Hearing Examiner Staff Report and Recommendation

Project Name: Rase Stream Buffer Reduction for Single Family Residence Replacement
Type of Application: Critical Areas Variance (CVAR)
Permit Number: 23-03173

1930 Northlake Way N.W.
Bremerton, WA 98312
Commissioner District 3

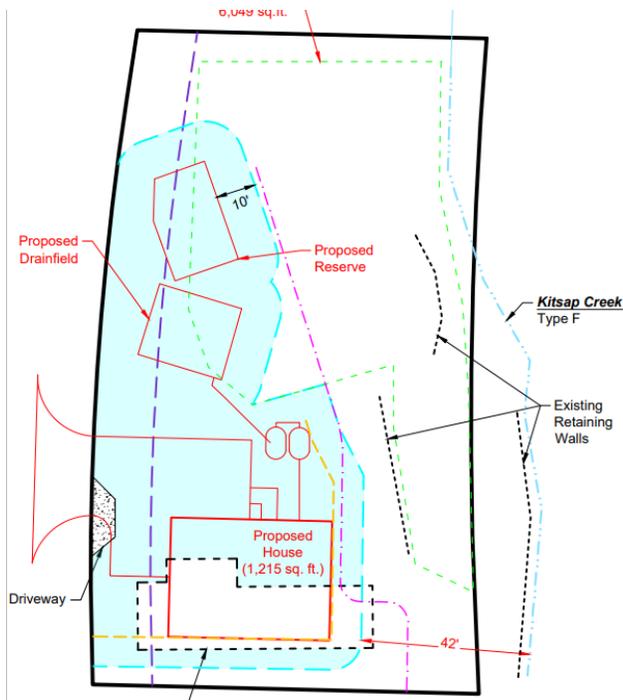
The image below shows both previous and proposed footprints of the single-family dwellings, the driveway entrance with associated parking area, onsite septic (OSS),

including drainfields and existing retaining walls for the benefit of the single-family residence east of Northlake Way, N.W. The site plan also shows the location of the offsite & onsite stream in relation to the site. The replacement home proposes a 42 foot buffer and 7.5 foot building setback, and further landward than the original home's footprint.

Mitigation Plan by ELS (HMP Figure 9)

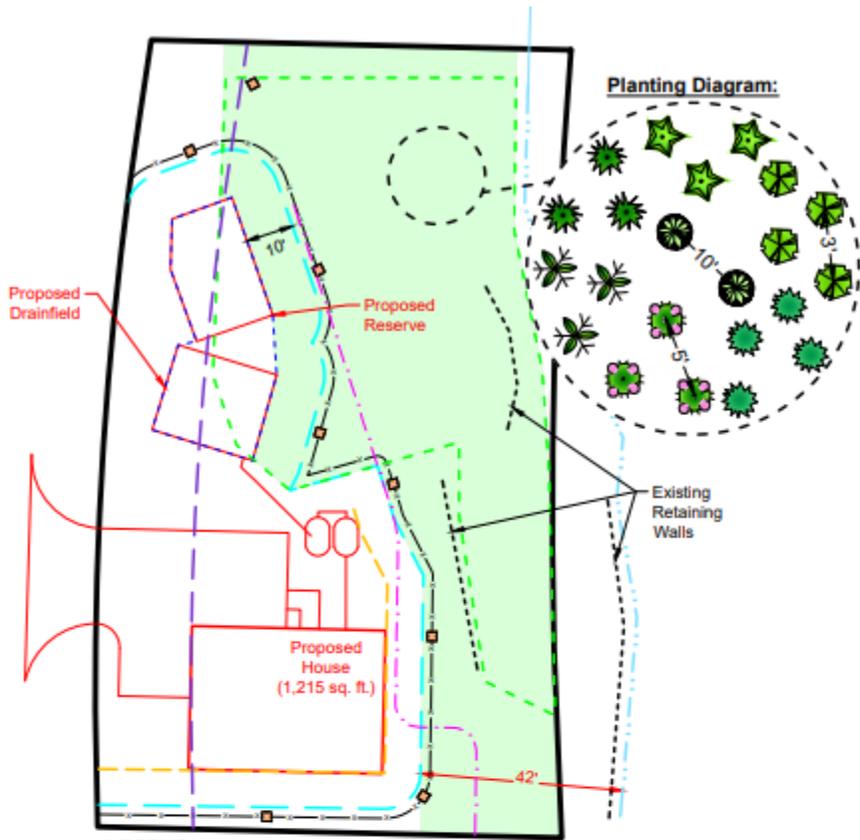
The total mitigation area encompasses 8,439 square feet, which includes two distinct planting zones: a 7,489 square foot area designated for native fern, shrub, and tree plantings, and a 950-square-foot area over the drainfield allocated for a northwest wildflower or native grass mix. If we consider only the zone with only native plantings, the mitigation ratio is 1.23:1. However, when we include the additional 950 square feet of wildflower/grass mix over the drainfield, the overall ratio increases to 1.38:1, as explained in the letter from ELS, error in the most recent version of the HMP. Pages 6 and 7 of the HMP distinguish between the two planting areas. The 1.23:1 ratio shown on Page 7 is actually 1.38:1, as shown in Figure 9 of the HMP:
